Preliminary Comments

Calcined Solids Storage Facility

Storage Facility Partial Permit Renewal for the

Idaho Nuclear Technology & Engineering Center on the

Figure 6. Inundation map for the 100-year flood piping failure.

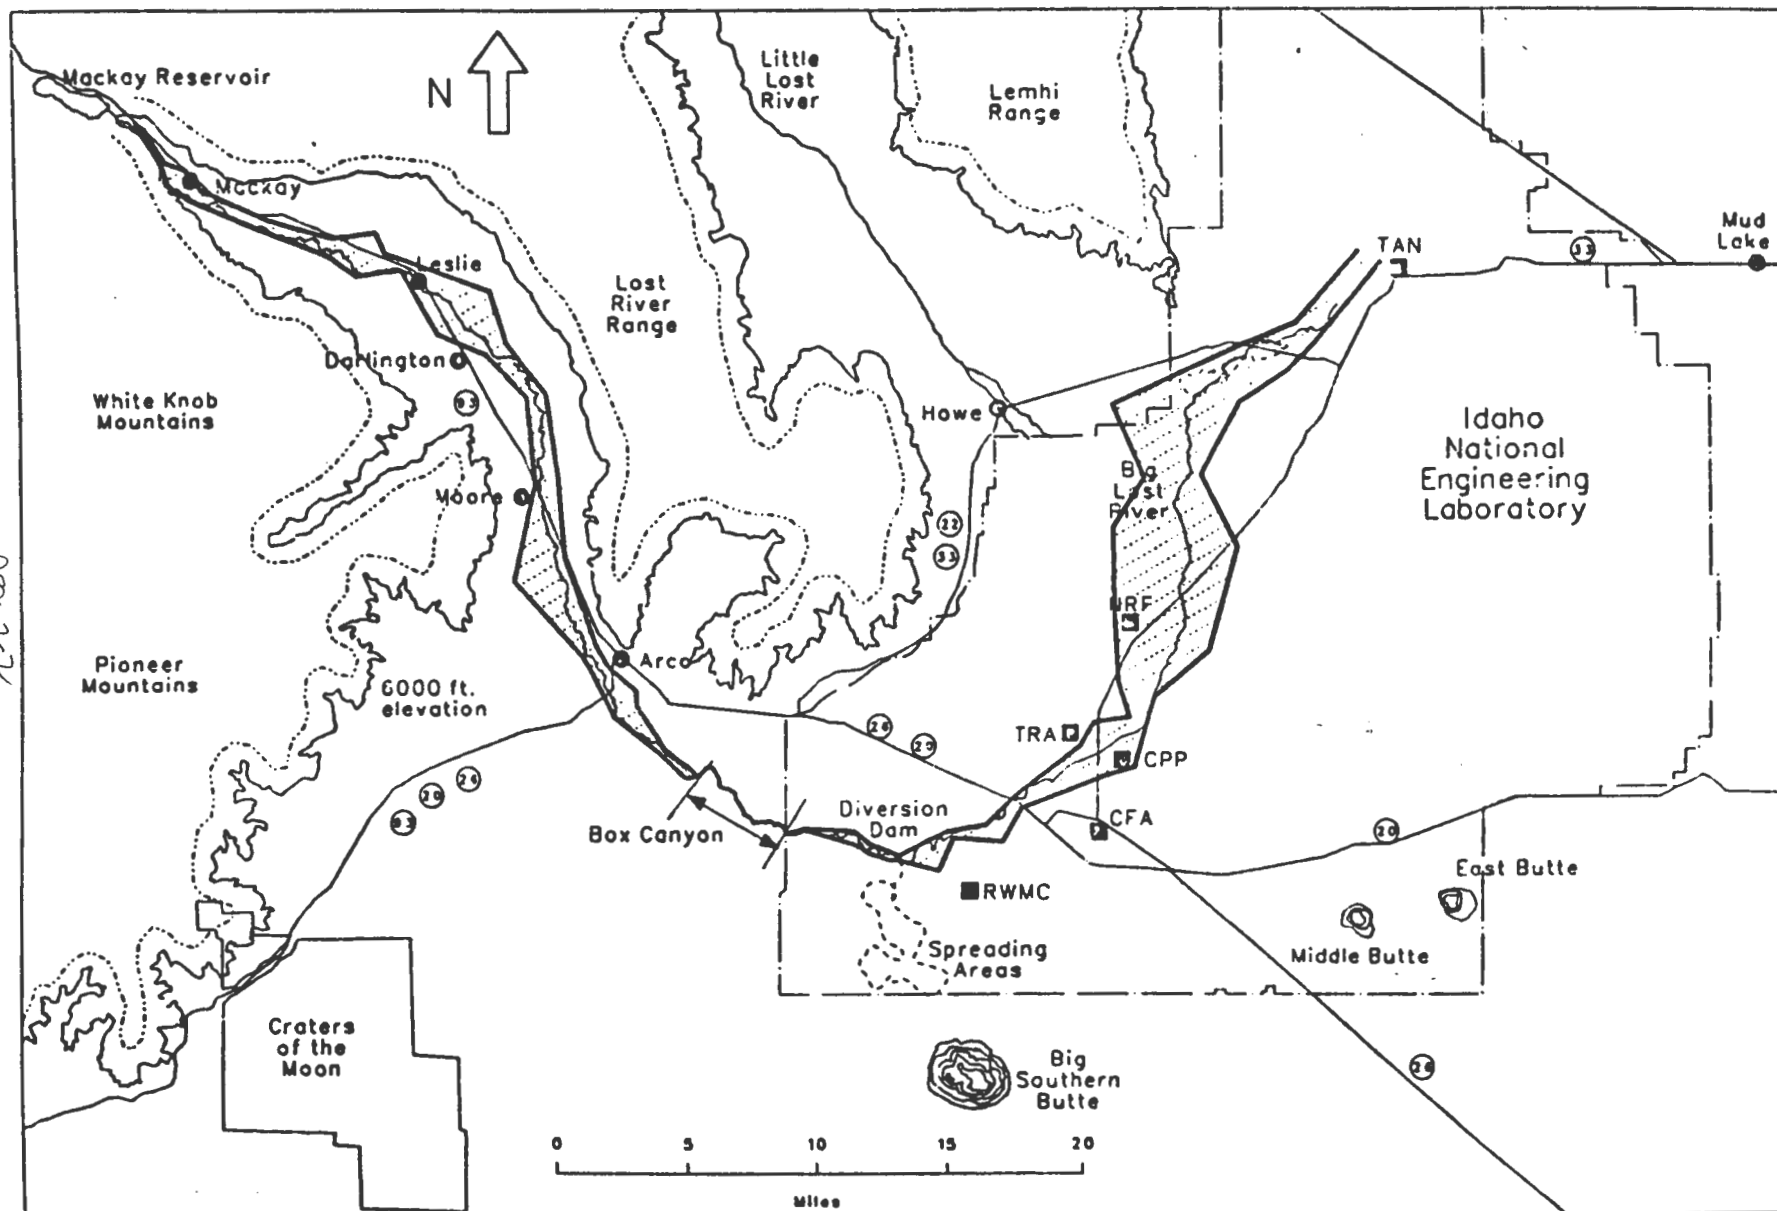
The USGS flood map (see attached maps) show the northern half of the INTEC under water. The USGS flood map shows the INTEC elevation of 4,917 feet and the USGS predicted elevation of 4,912 feet through the middle of the ICPP. The USGS study also employed current modeling technics and plotted 37 separate cross sections on the INL site. The INTEC as a whole is about as flat as a table top with only a couple feet change in elevation north to south.⁴⁶

The Engineering Design File used in the Permit acknowledges: “The floodwater elevation for the postulated flood is 4,916 ft. and the flood water depth at INTEC is approximately 4 ft.”⁵⁰ Also stated is the elevation of Bin Set # 1 is 4,867. That means the Bin Set # 1 will be ~56 ft. below the flood water which will add significant hydrologic pressure on the non-water tight concrete casing with the potential of floating the bins, severing connecting coolant piping and exposing workers to unshielded radiation. [Pg.3 and 4]
